Powell Butte

LU 10-169463 CUMS EN AD

Proposed revision to Decision of Council, Page 67

PWB Response to Powell Butte Appeal Issues 2/3/2011

Hazard Notification Area

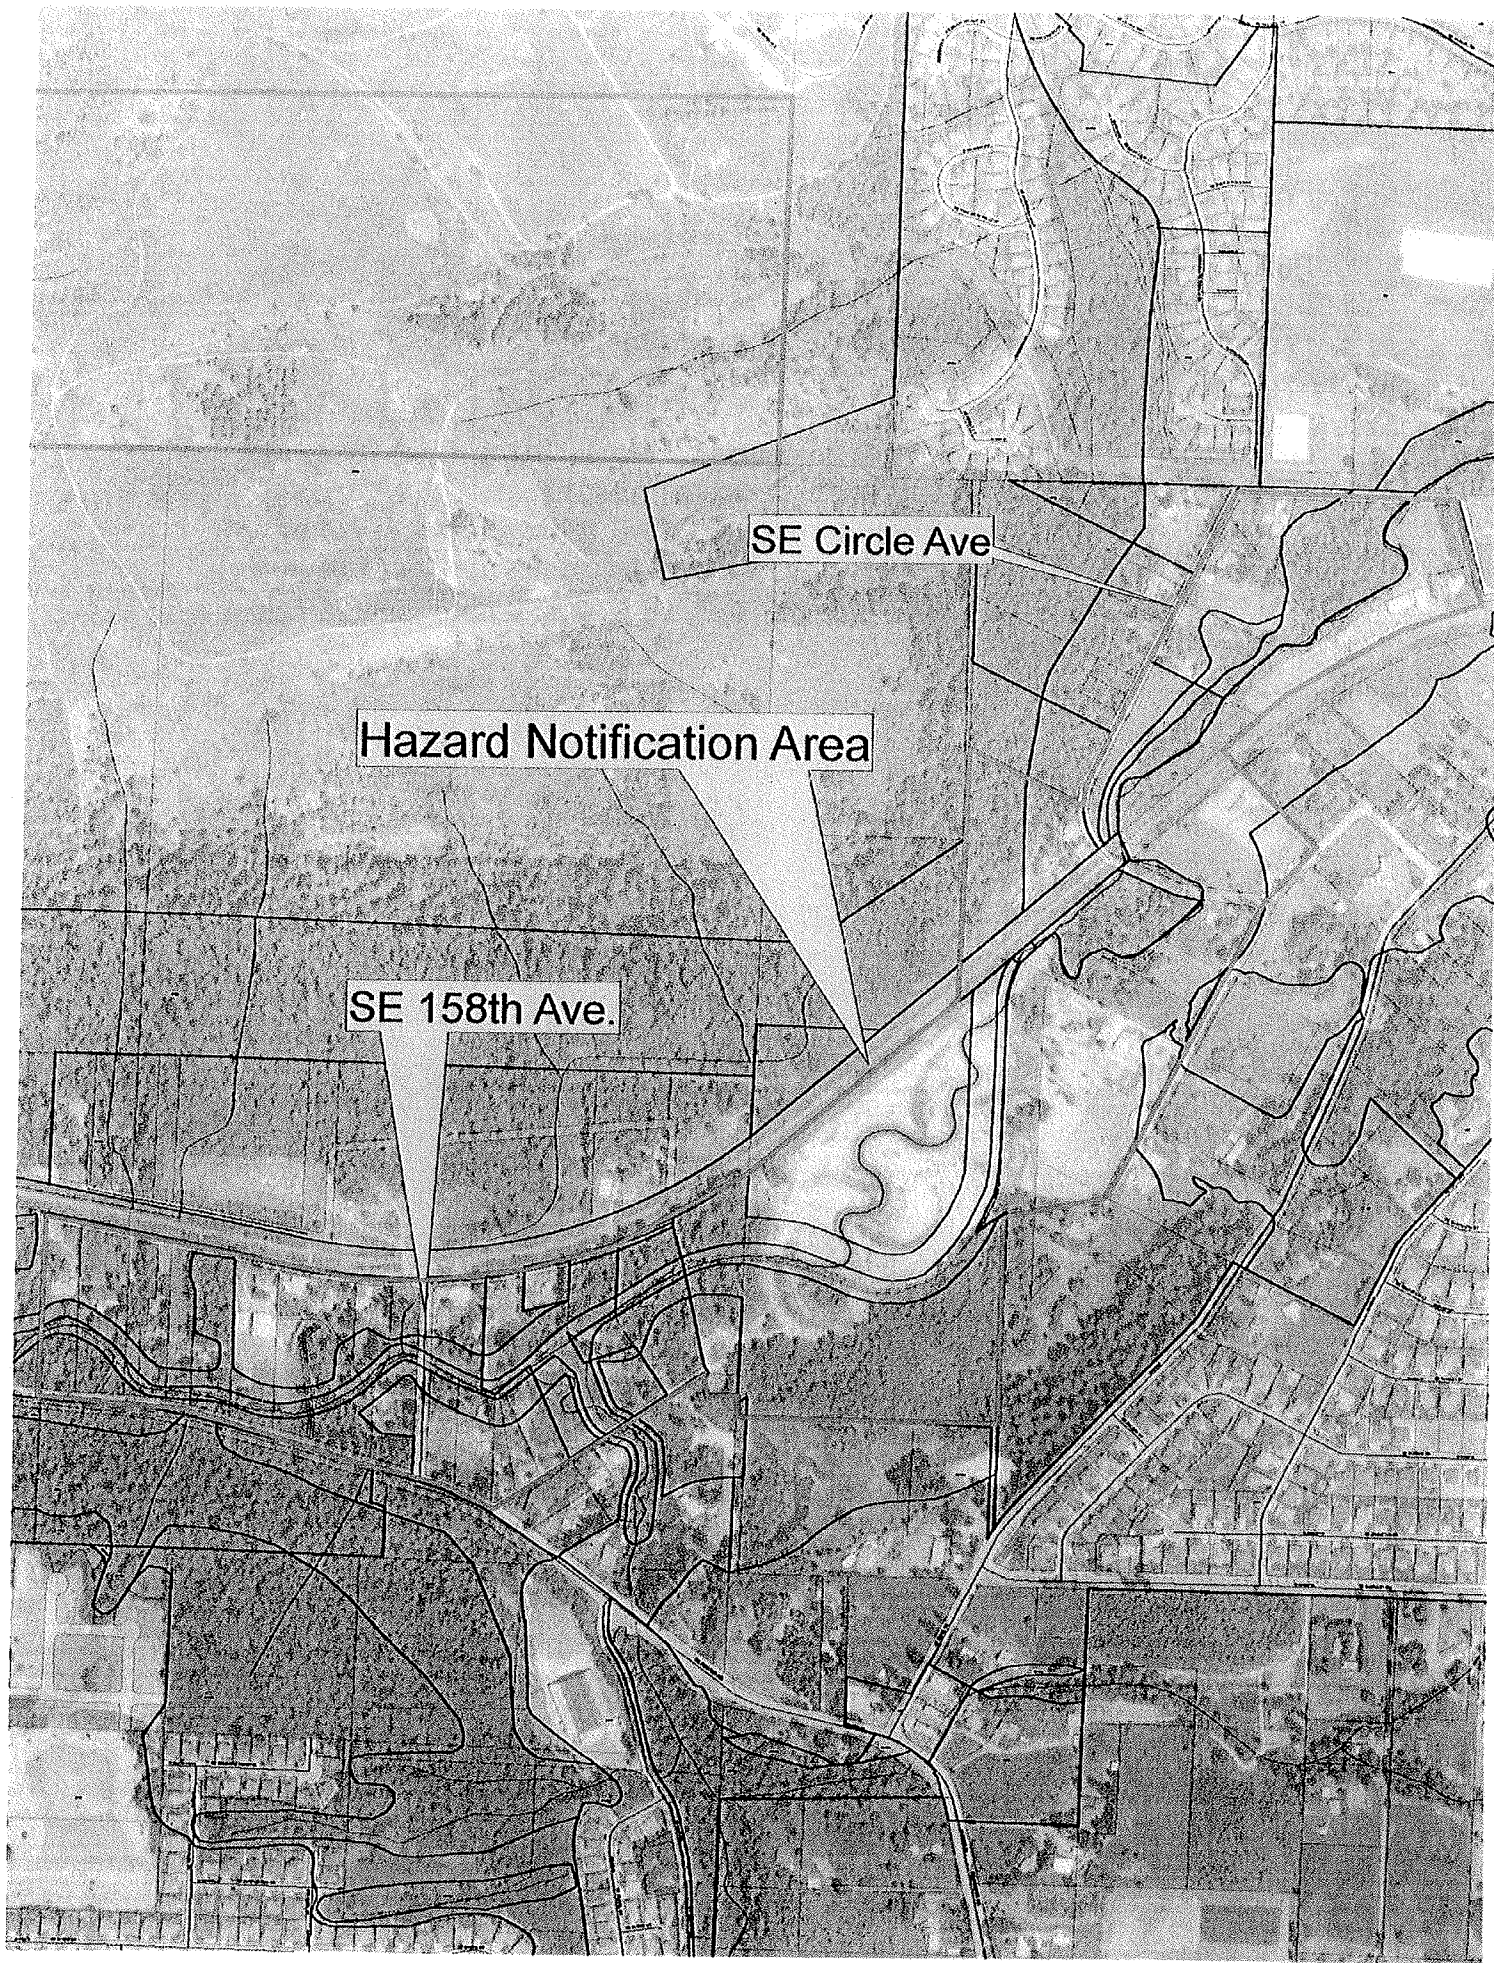
- G. At time of building permit review, the Water Bureau will submit documentation that the Water Bureau has directed the Portland Office of Emergency Management [POEM] to develop a specific Emergency Notification Plan for ~~all residents downstream of Powell Butte~~ the residents in the Hazard Notification Area indicated on the attached map.
